Comment Tracking Table – April 2025 Resubmission
556, 560, and 576 Conservation Drive

Comments dated: February 18, 2025
Date: April 15, 2025

Trail Grading Details and Cross Section:

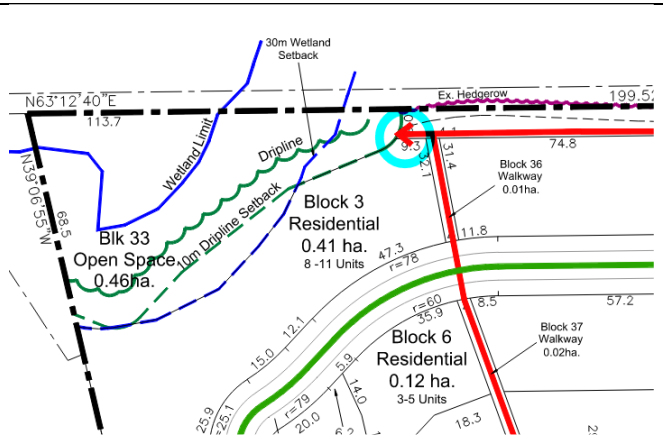
A trail in this location was proposed two submissions ago. At that time, through comments issued on March 3, 2023, Environmental Planning staff noted that a trail in this location had not been explicitly contemplated in the EIS and that the EIS would need to be updated to demonstrate that a trail would not reduce the integrity and functionality of the buffer. In response, through the last submission, the trail was removed and Environmental Planning staff noted, through comments provided in 2024, that the Active Transportation Plan still showed a connecting arrow (circled in light blue below), suggesting the trail will continue westward, and requested that the arrow be removed.

Based on this, and the grading challenges that exist with the property to the west, it is unclear why the trail is once again proposed. If the trail, infiltration galley, and retaining wall continue to be proposed and are within the wetland buffer, as shown on the engineering drawings, the EIS needs to be updated to address them. If the trail, infiltration galley, and retaining wall are eliminated, or if the engineering drawings are revised to move them outside the buffer, then the EIS does not need to be updated.		
53	Environmental Planning Staff note that the EIS has not been updated to include the most current Draft Plan or Block numbers. Ideally, these updates would be made. However, if the trail, infiltration gallery, and retaining wall associated with Block 32 (discussed above) are eliminated or it is confirmed that they will be outside of the wetland buffer, and the engineering drawings are updated to reflect this, then the EIS does not need to be updated.	GSP/ NRSI	All plans have been updated to show the elimination of the trail to the west, infiltration galleries and retaining wall. The Draft Plan has been revised to ensure the trail connection to Rideau River Street can be constructed without the need for any retaining walls.

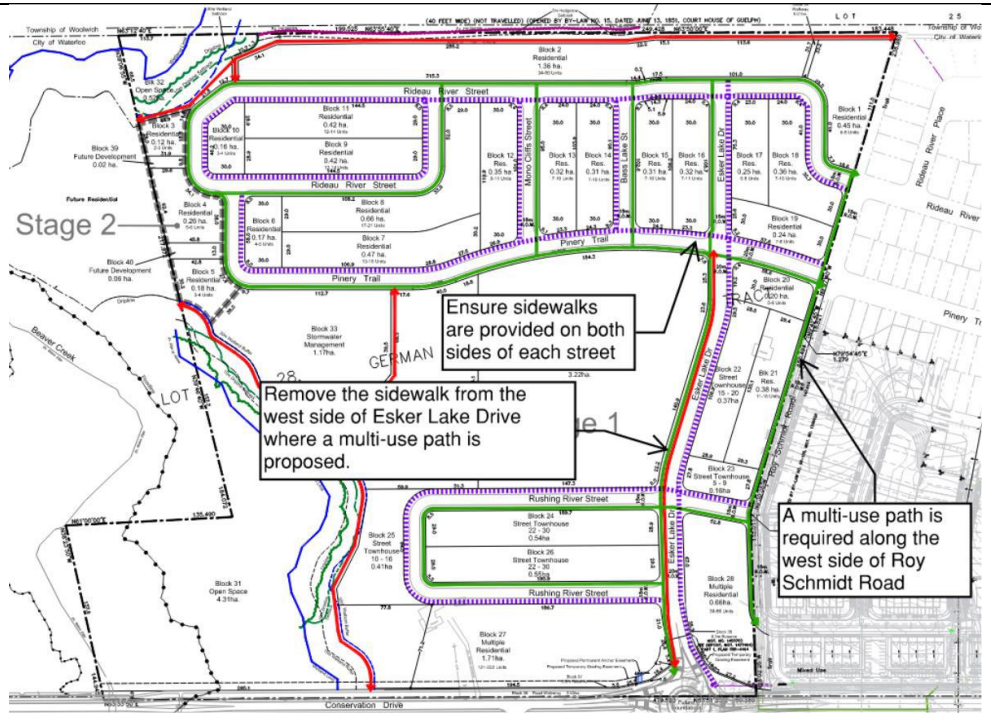
3.e	All pipes and other encumbrances should be strategically planned to permit shade trees along the trails and throughout the park. Please confirm that trees will be planted on the south and west sides of the trails, considering the	GSP	Please refer to revised Preliminary Park Plan (dated March 21, 2025)

proposed location of the sanitary easement. Currently, the alignment of the service within the easement (close to the east edge) would result in encroachment beyond the easement for any future maintenance and would also impact tree planting adjacent to the pathway. Please demonstrate this on the revised Landscape Sketch. Trees shall be planted as part of park construction within Stage 1. Provide the sanitary depth and accurate easement limits for the Park Block.		Proposed 4.0 metrew wide landscape buffer noted between sanitary access and future SWM facility
4	Further to the above, it appears that many other comments dated June 29, 2023 by Daniella Giovanatto were not reflected in the revised park concept plan despite the comment response noting the Preliminary Park Plan has been revised in accordance with comments provided by the City on June 29, 2023. Staff note that as per the Comprehensive Engineering and Landscape Manual (CELM), a City-approved Park Concept Plan shall be in place prior to the formal public meeting and registration of the subdivision. This will be a standard condition of Draft Plan Approval.	GSP	Please refer to revised Preliminary Park Plan (dated March 21, 2025)
